PLANNING COMMISSION AGENDA

Tuesday, April 05, 2016
Breckenridge Council Chambers
150 Ski Hill Road

7:15pm	<i>Final Hearings</i>	
	1. Denison Placer Housing Phase 1 (JP) PL-2016-0011; 107 Denison Placer Road / TBD Floradora Drive	57
	2. Denison Placer Housing Phase 2 (JP) PL-2016-0012; 107 Denison Placer Road	111

**T1.2
LIGHTING
PLAN**

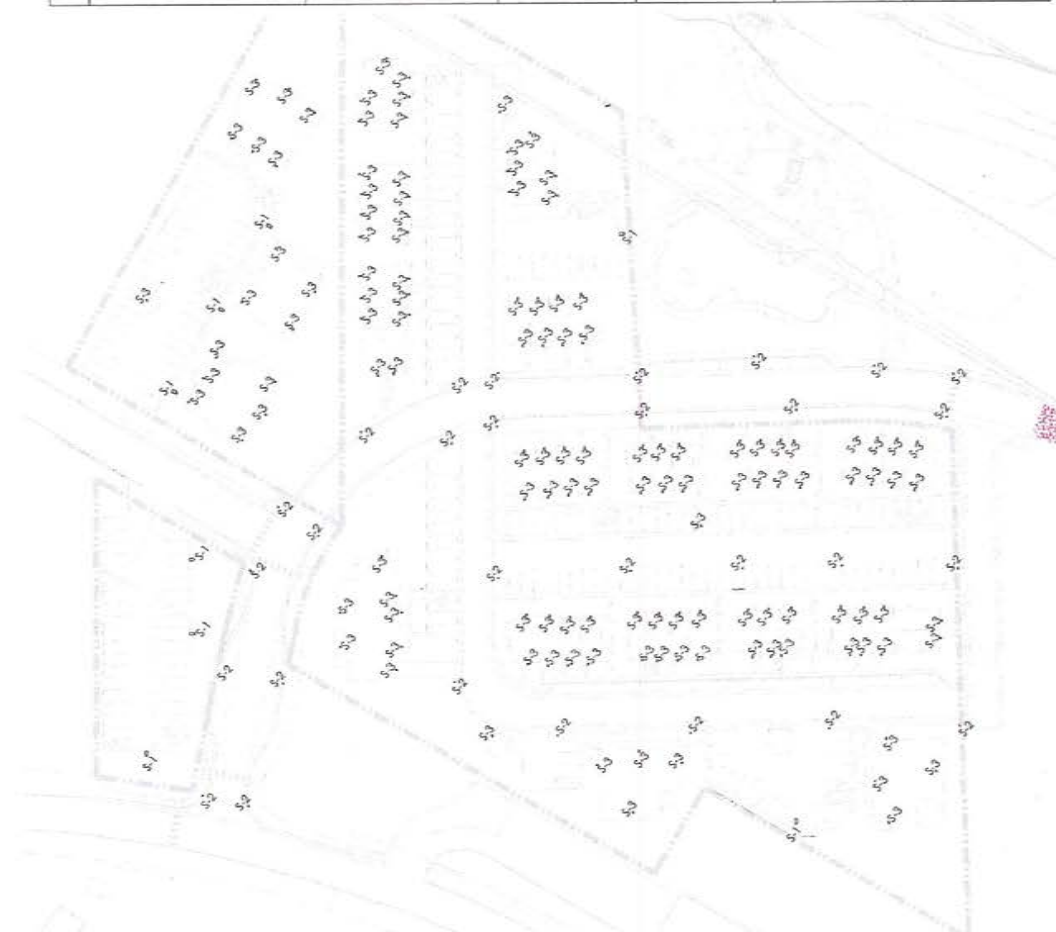
Exterior Lighting (Sec. 9-12): Three parking lot lights are proposed with a full cut off fixture (type S-1 on Sheet T1.2). The fixture may be a maximum height of 18 feet with a required setback equal to the fixture height. This is being met with this application. All fixtures will also meet the lighting requirement of 0.2-1.5 foot candles for parking lots.

1/8" = 1'-0"
A8.1
BUILDING F1

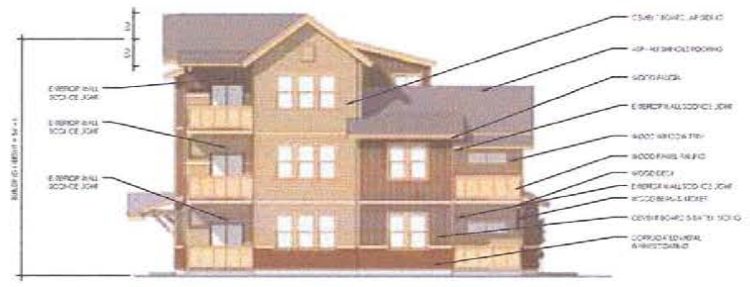
This is the F1 Building. We increased the overhang, and added some mechanical space. It resulted in this little change here. (Ms. Dudney: I like how that breaks up that elevation.)

A9.1
BUILDING F2

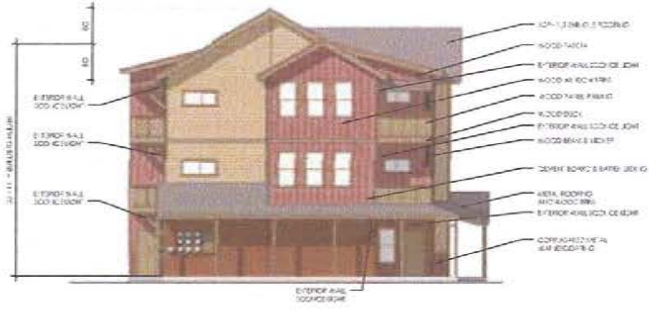
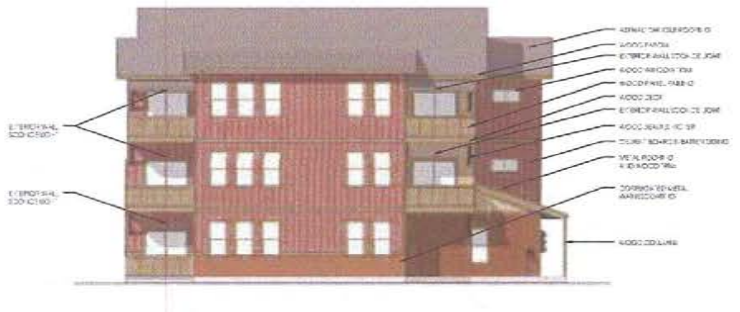
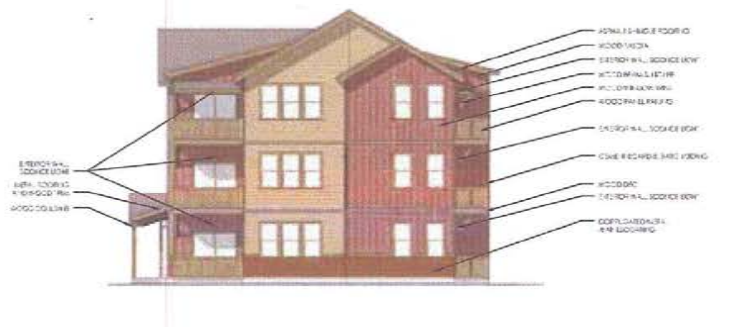
F2 Building is similar but different. Has storage for all of the F Buildings in phase 2. (Mr. Schuman: What corner is Mr. Pringle most concerned about?) It does step back. (Mr. Schroder: I was thinking about solar access, so it doesn't look like it would be in the shade all the time.) (Ms. Puester: There is 6 feet of difference.) (Mr. Pringle: I have to say that the porches add so much more interest. I generally like these buildings but I don't know if I like the back 3 story element portion that is just flat. I don't know if there was anything more that can be done. If there was an objection, it would be on that side.) (Ms. Dudney: I think it looks pretty good.) (Ms. Leidal: What is the garage door material on the community building?) Not sure yet. We have some views of our overall site model. We put this image in the slideshow to show the variation. At any point in the project, you would be hard pressed to find the same building type. (Pete Weber, Coburn presented a 3D slideshow.)
